Figure 1: Bushfire prone areas around the Wahroonga Estate showing limited exits

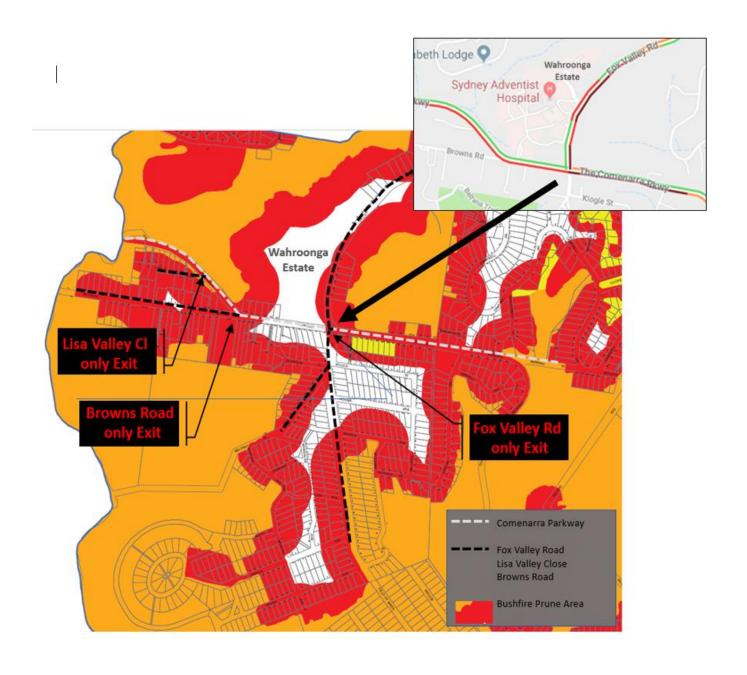
Please look at our own local trap below. I live there with my family, and about 1200 other people. There is only one way out, but for services also only one way in. Imagine Fox Valley road and Comenarra parkway in the event of a catastrophic bushfire as we saw yesterday - jammed due to over-development, and congested by hundreds of cars trying to leave, whilst fire vehicles are trying to get in. We have addressed this so many times but our concerns have continued to fall on deaf ears — hopefully that is, until this hearing.

Figure 2:

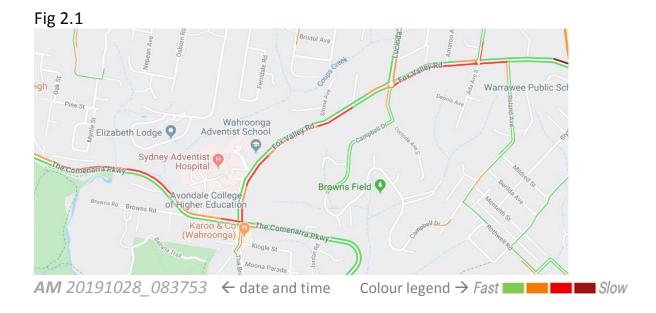
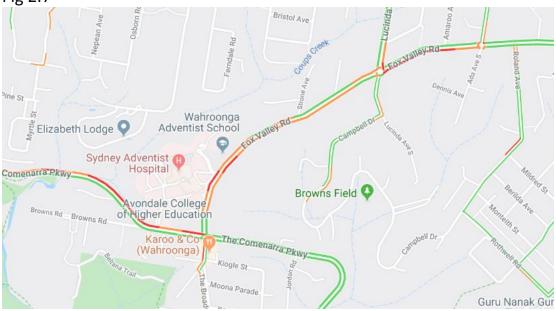
In the MP07_0166 MOD8 Modification assessment, the developer keeps claiming any traffic condition other than MOD8 related is irrelevant. How can that be the case when anyone can see the ongoing and multiple real traffic congestion situations by using the NSW Government "Live Traffic NSW" pages to see what is really going on.
